Petitions – Stop the Coundon Cycleway, and Support the Coundon Cycleway

APPENDIX A - SCHEME DETAILS

These drawings are Post-Consultation.
The notes on the plans highlight the changes
made from the consultation drawings.

Project: Air Quality Action Plan
Coundon Cycleway

Title: General Layout
Sheet 7 of 17

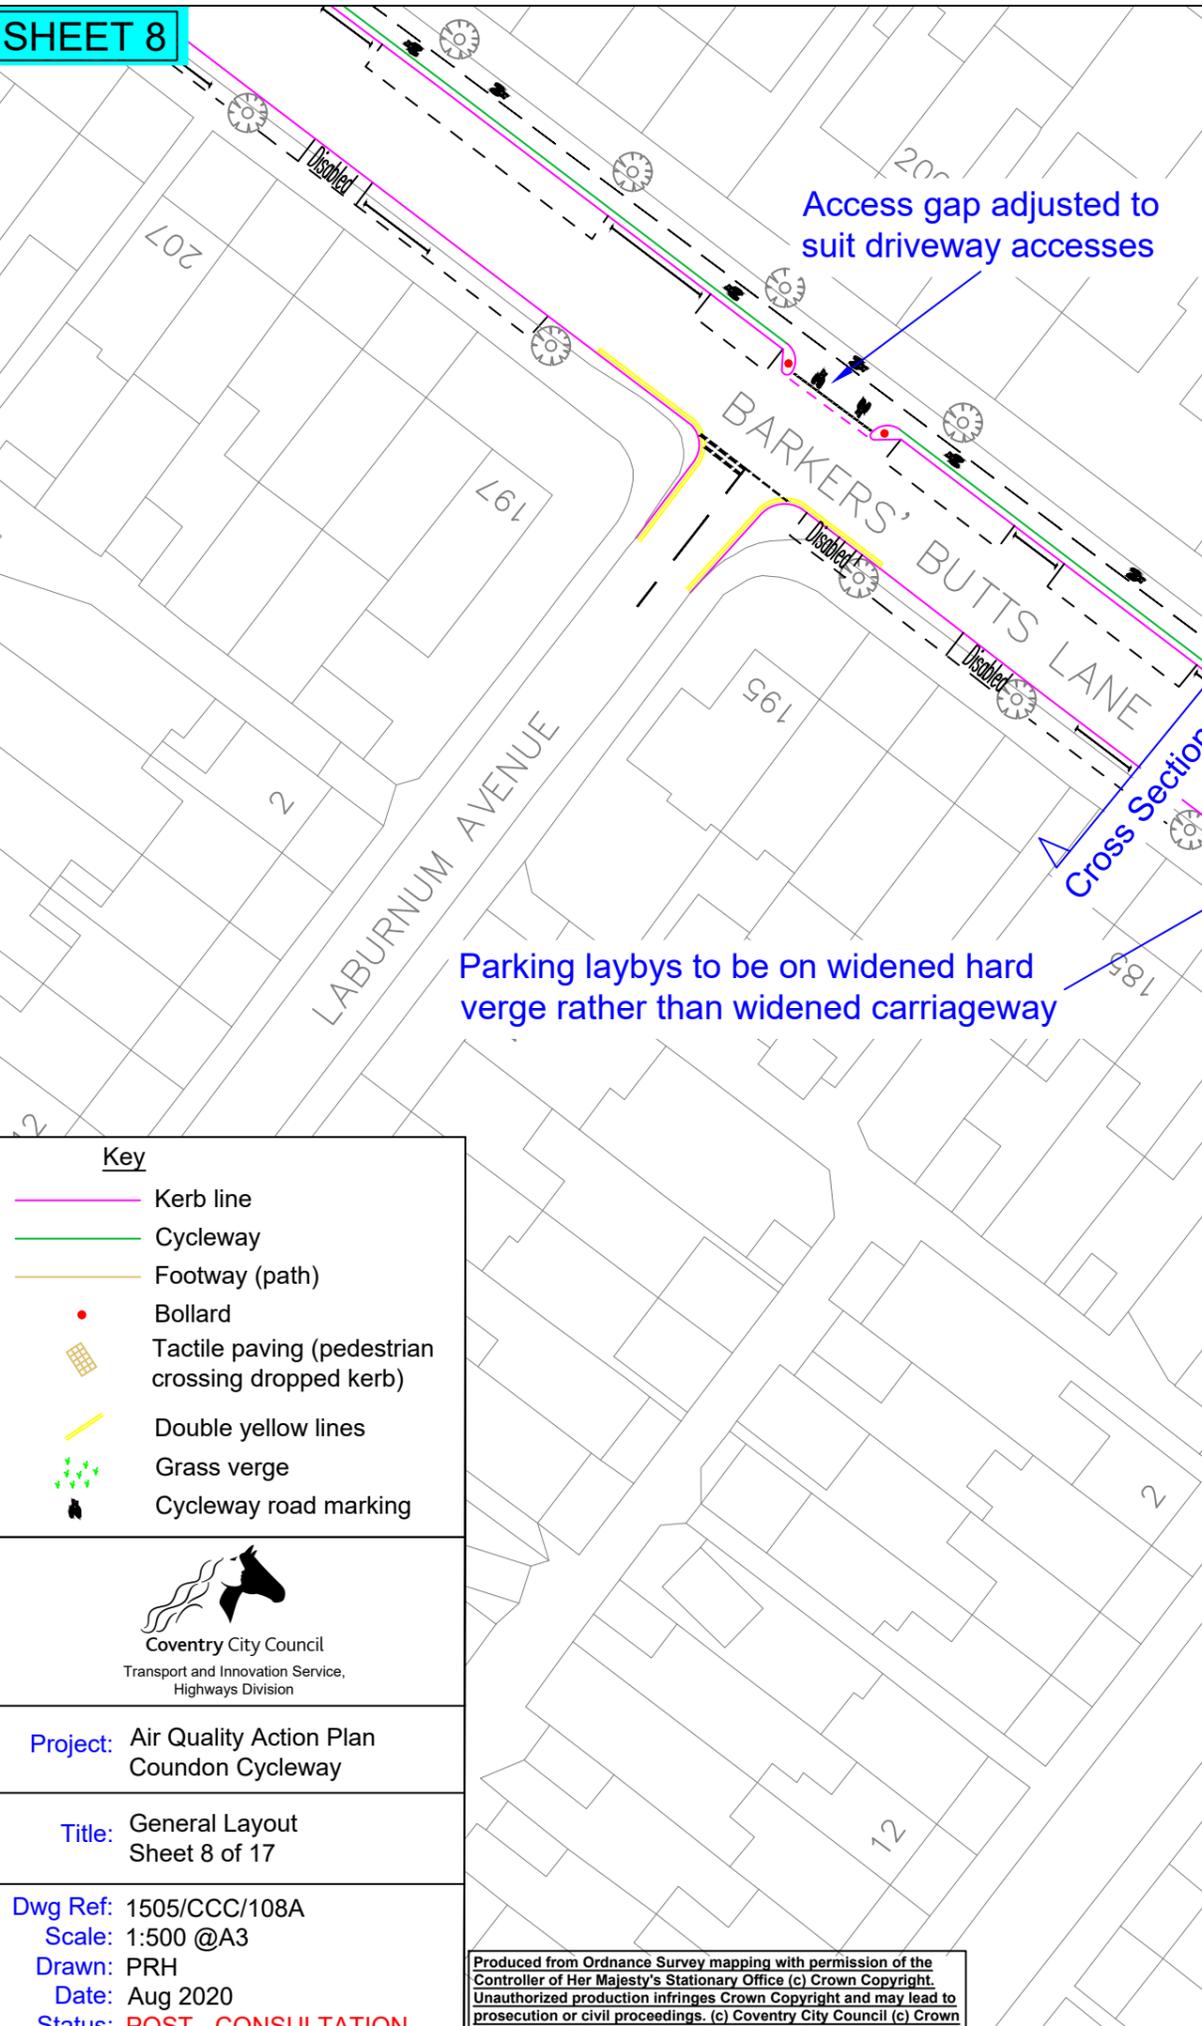
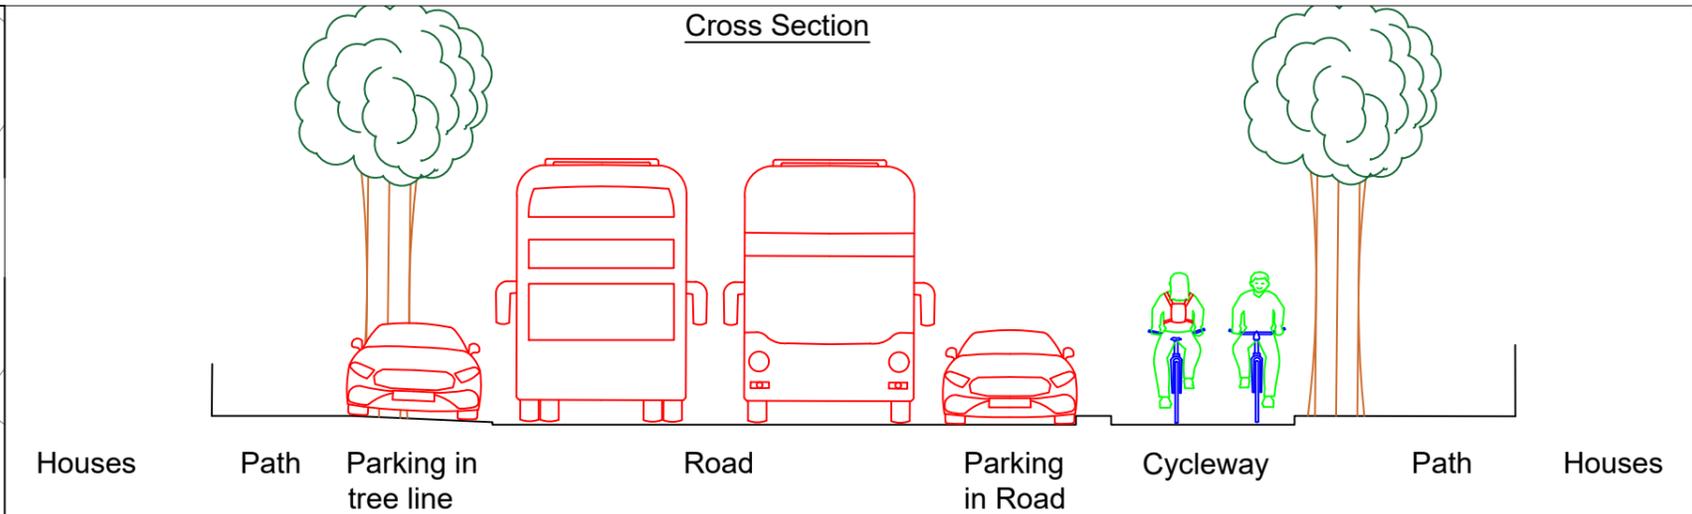
Replacement trees were suggested to be planted here, will now be further down Barker's Butts Lane where there is more space

Zebra crossing added for pedestrians to access floating bus stop

Parallel Crossing (zebra for people on foot and cycles) alignment has been adjusted

The junction will take the form of a 'Dutch Style Entrance'. This means road traffic has to traverse a kerbed ramp to cross the cycleway and footway, rather than the cycleway and footway dropping down to road level. This further enforces the change in priority to cycles over vehicles and provides priority for pedestrians also.

Parking laybys to be on widened hard verge rather than widened carriageway

Title: General Layout
Sheet 8 of 17

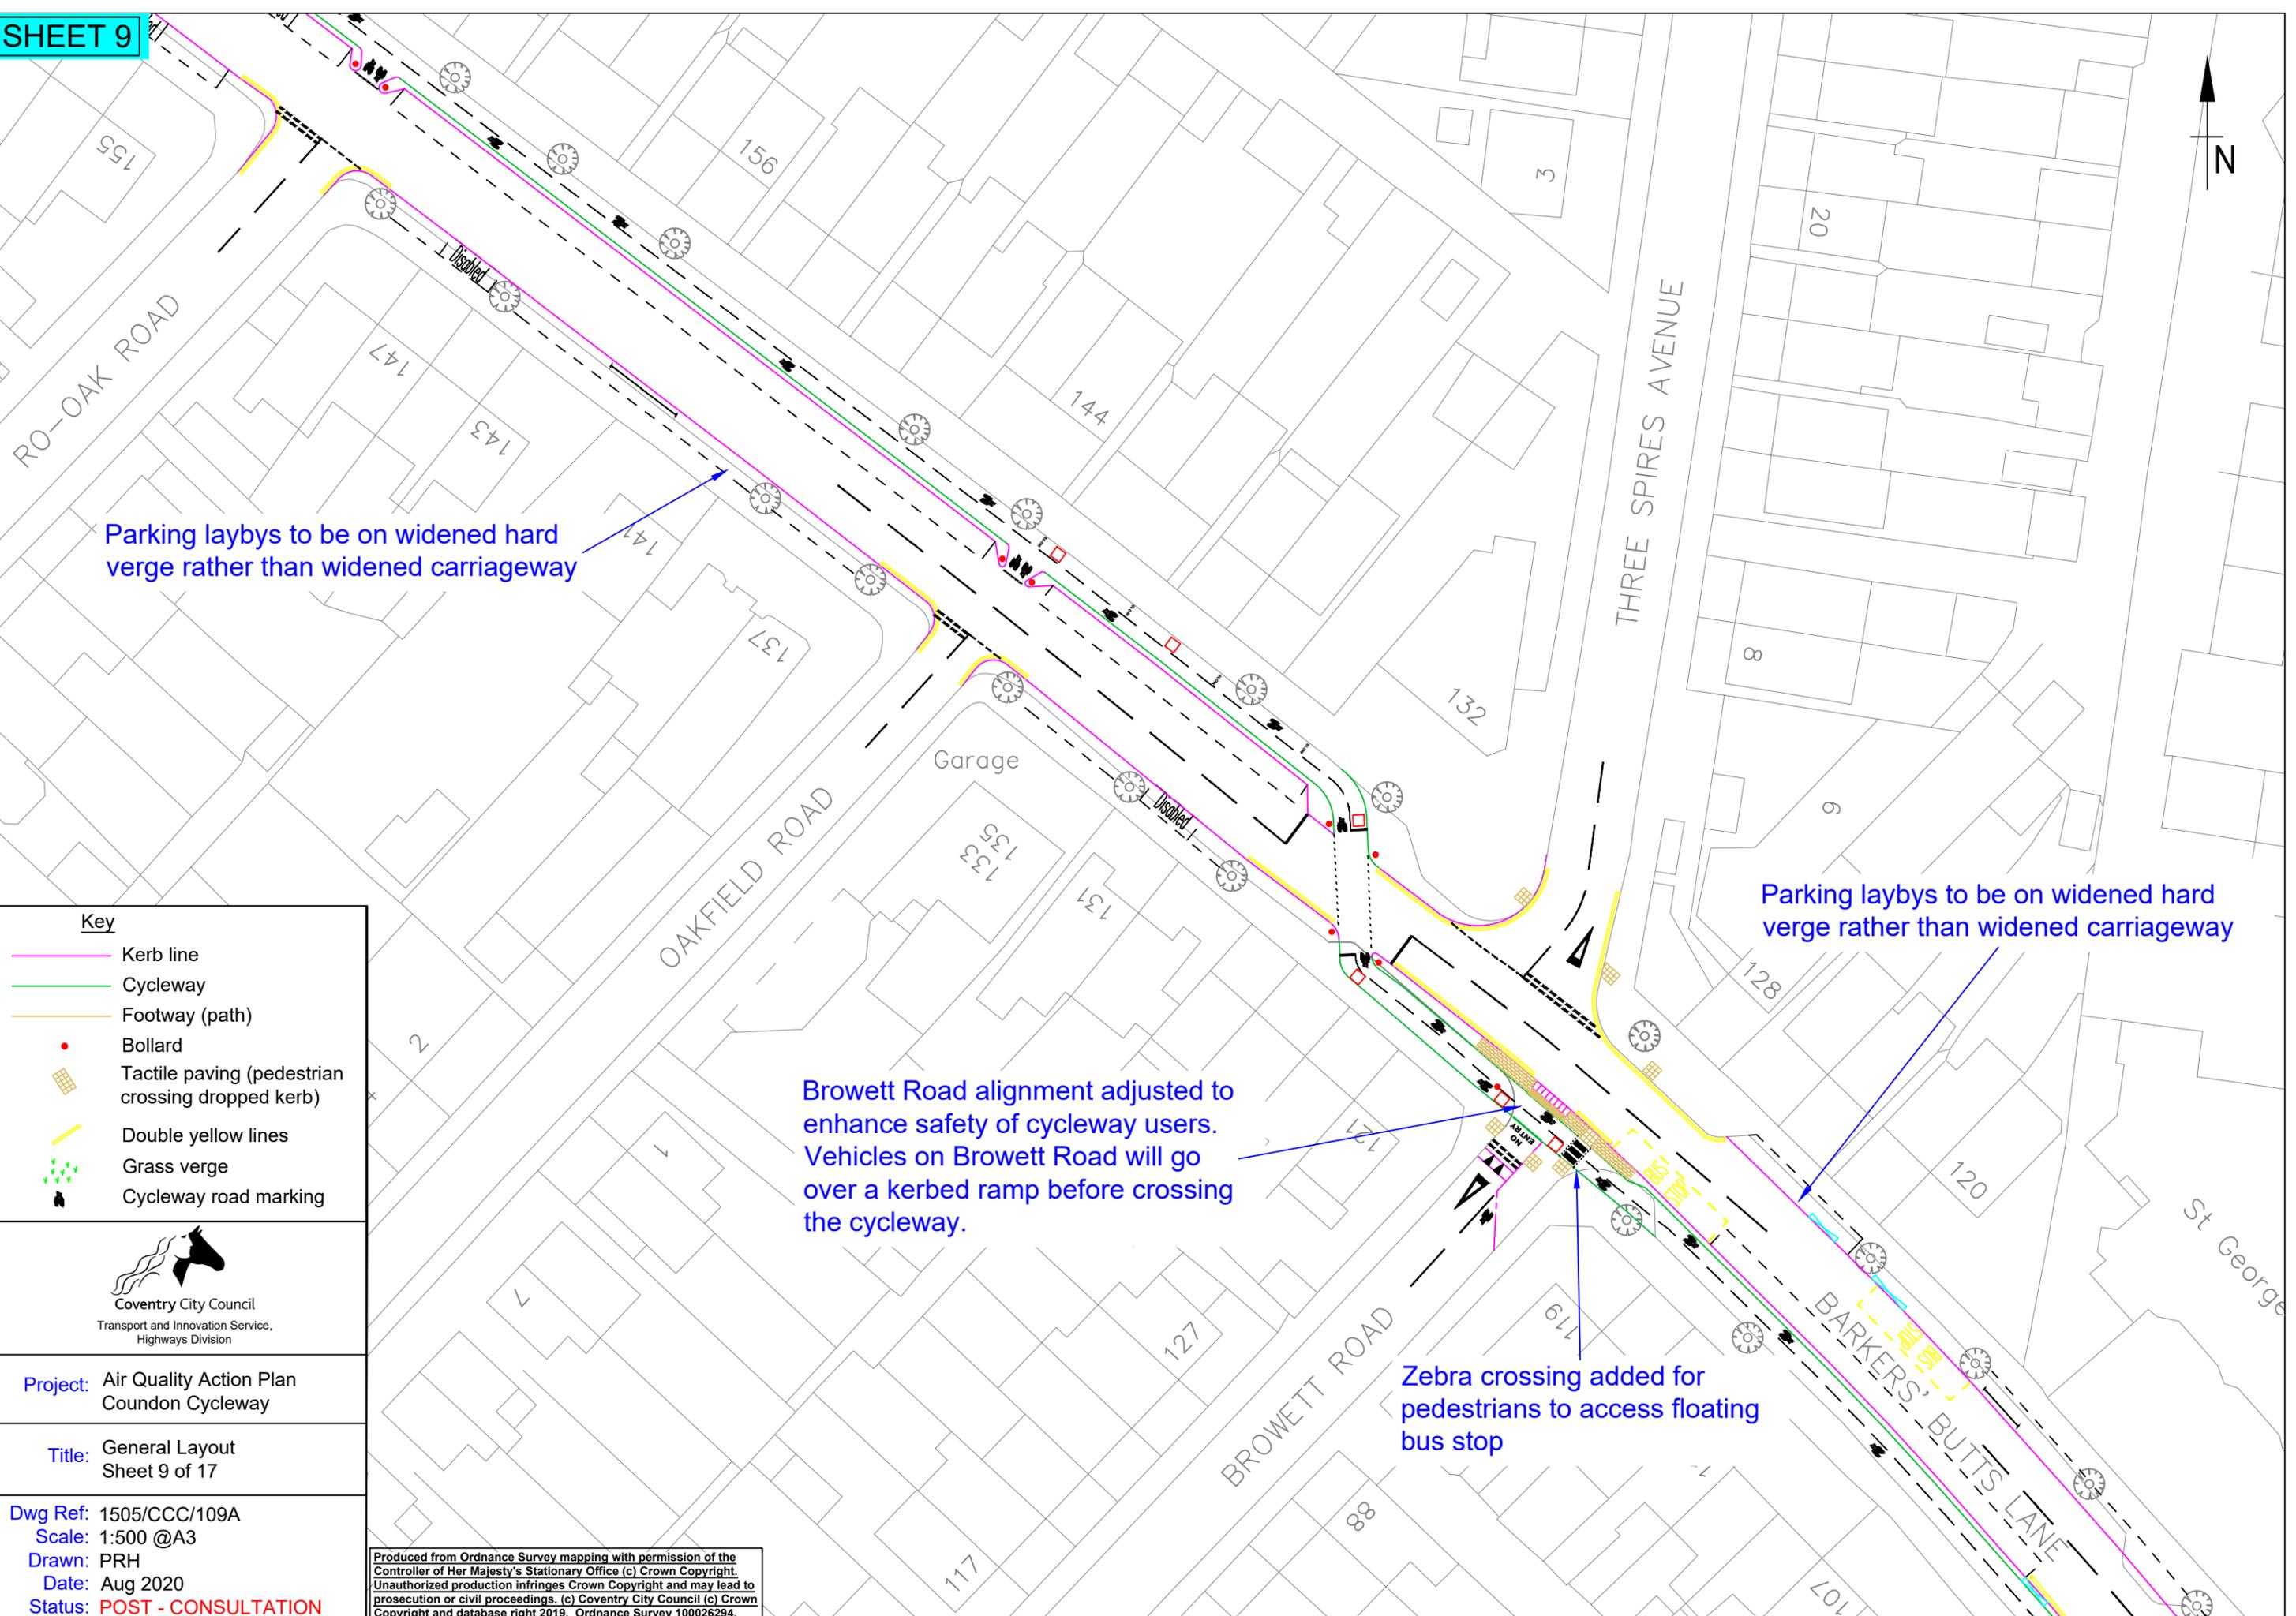
The junction will take the form of a 'Dutch Style Entrance'. This means road traffic has to traverse a kerbed ramp to cross the cycleway and footway, rather than the cycleway and footway dropping down to road level. This further enforces the change in priority to cycles over vehicles and provides priority for pedestrians also.

Title: General Layout Sheet 10 of 17

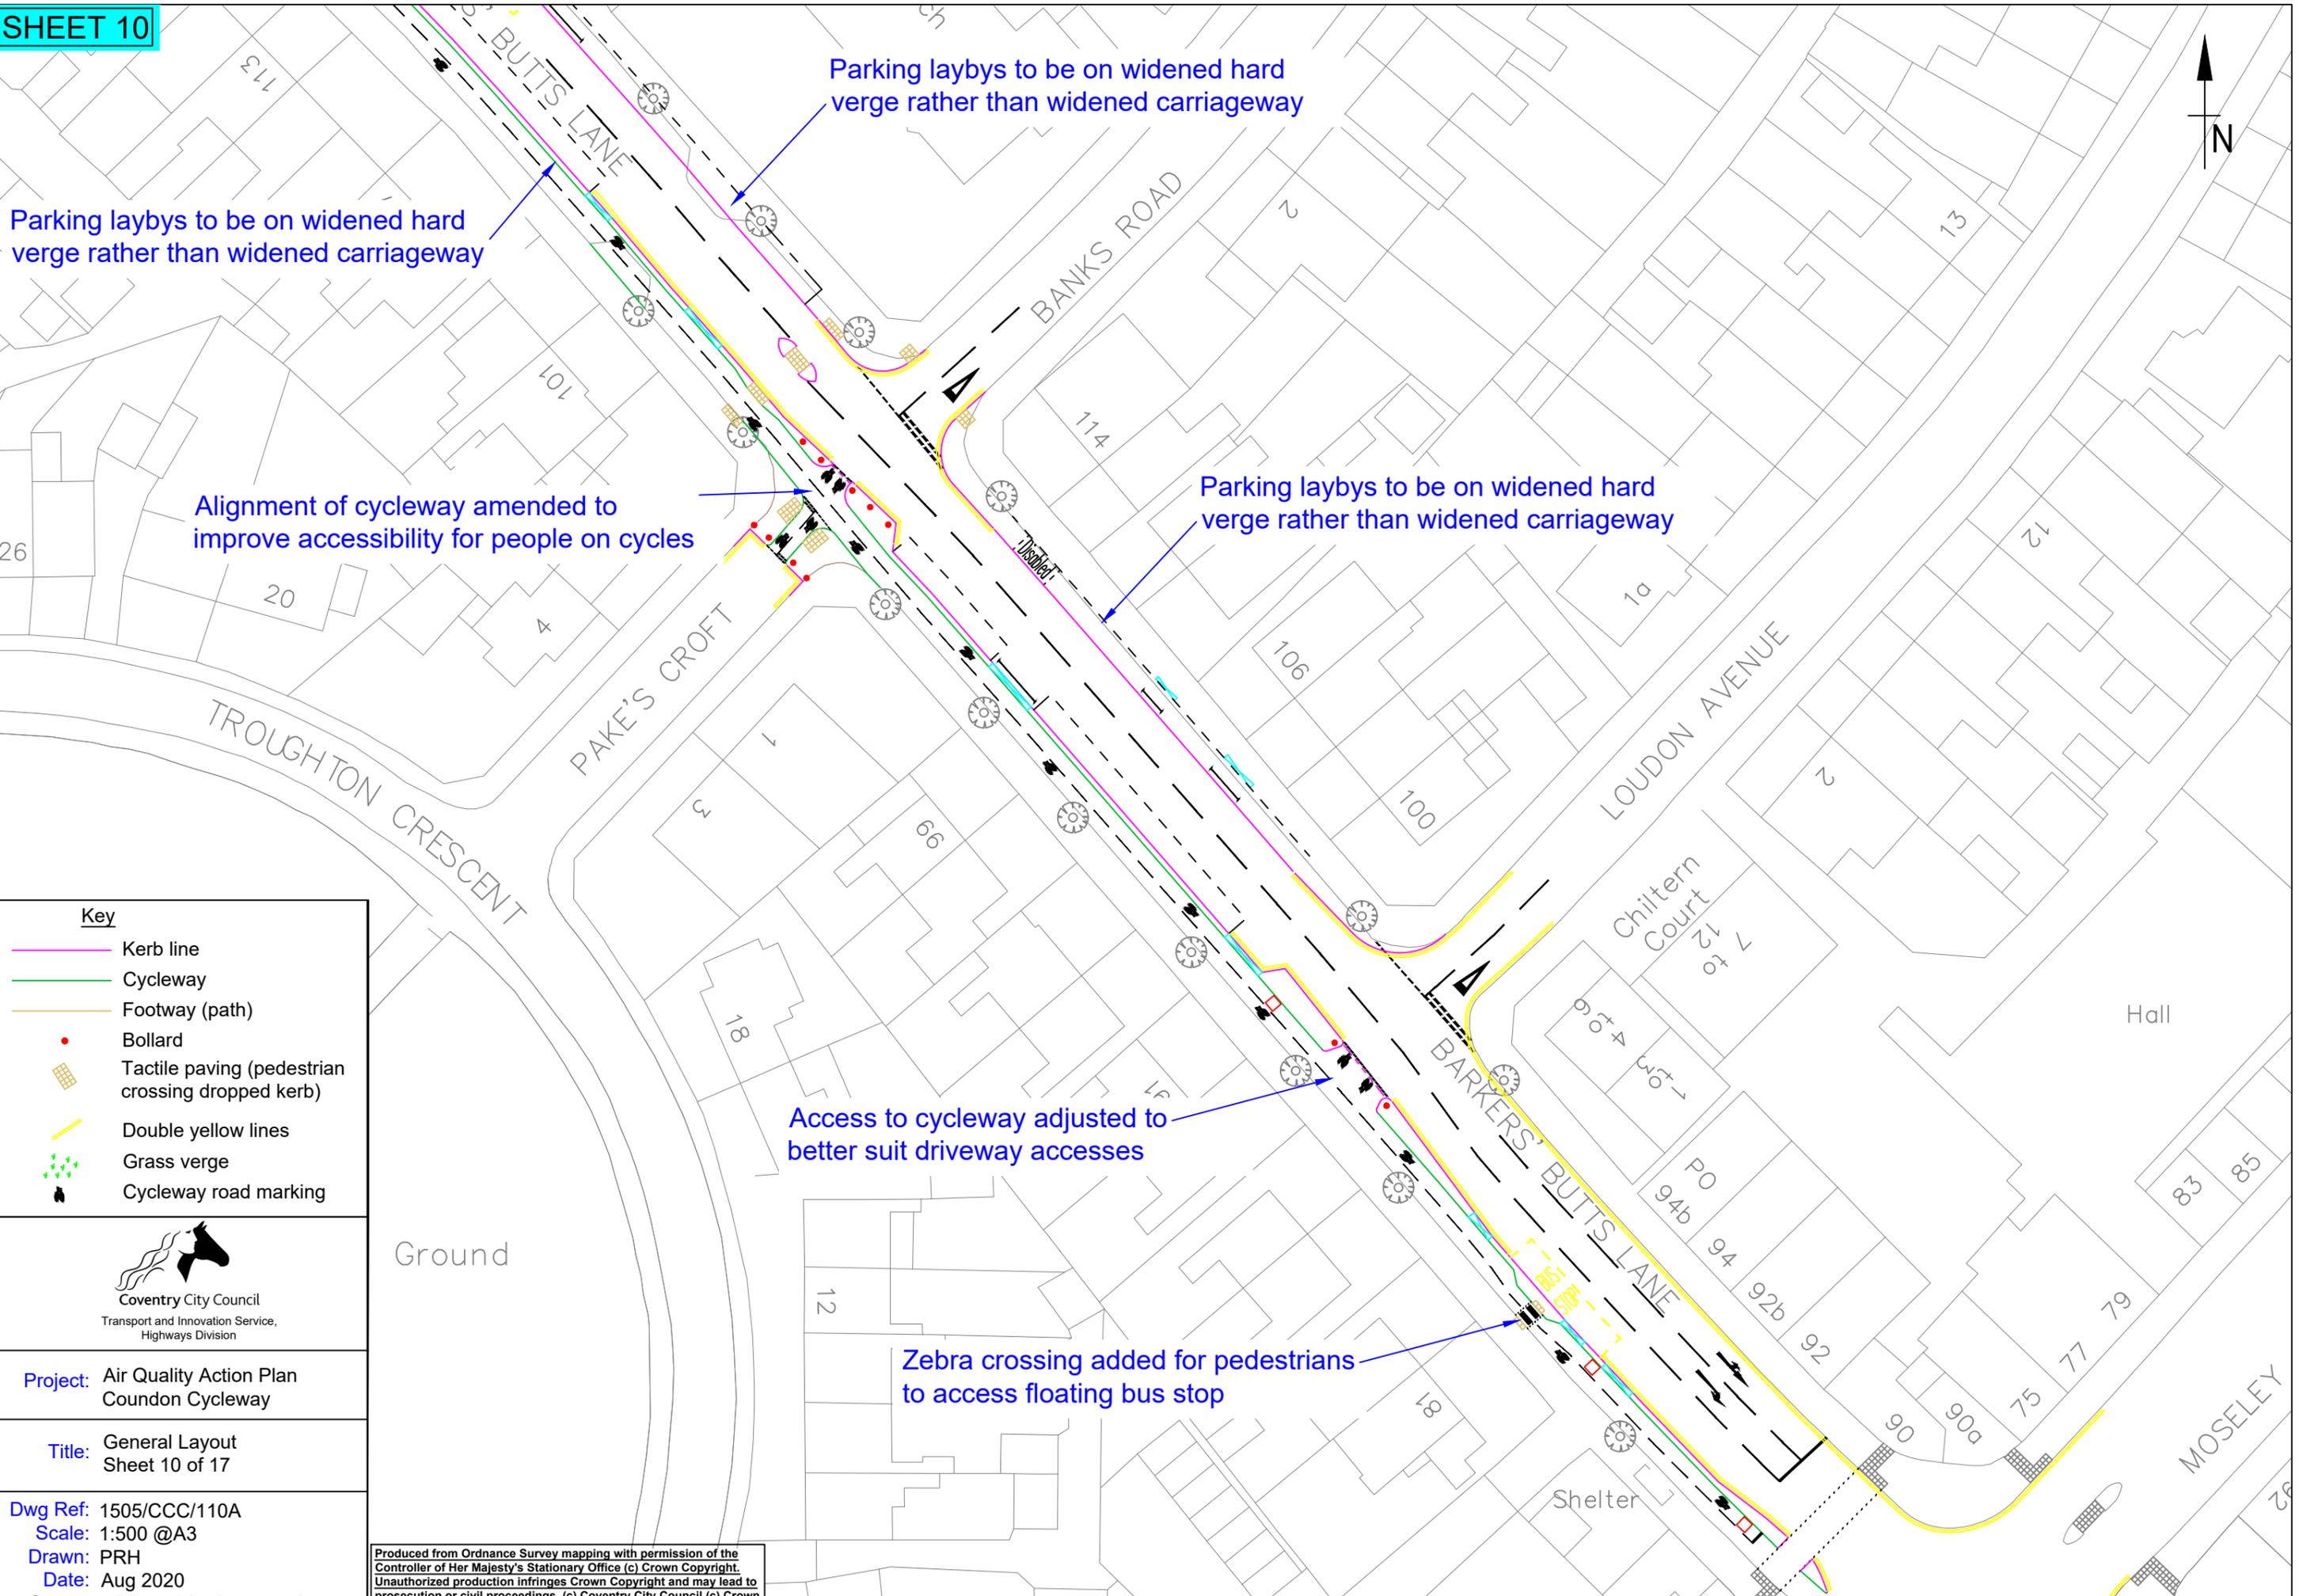
Parking laybys to be on widened hard verge rather than widened carriageway

Parking laybys to be on widened hard verge rather than widened carriageway

Alignment of cycleway amended to improve accessibility for people on cycles

Parking laybys to be on widened hard verge rather than widened carriageway

Access to cycleway adjusted to better suit driveway accesses

Zebra crossing added for pedestrians to access floating bus stop
